RCT107 TIMER (30 MIN)

INSTALLATION NOTES AND TIMER WIRING DIAGRAMS

RPI TIMER (RPI PART #RCT107)

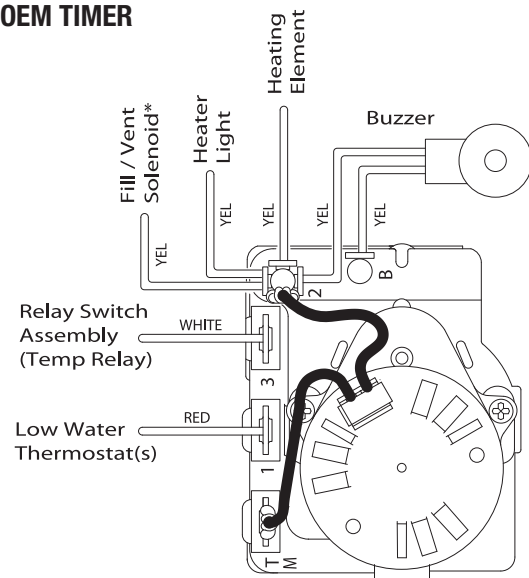
- **Connecting electrical leads.** See *Timer Wiring Diagrams* and note that the #2 contact and the "B" positions are reversed on the RPI Timer when compared to the OEM Timer.
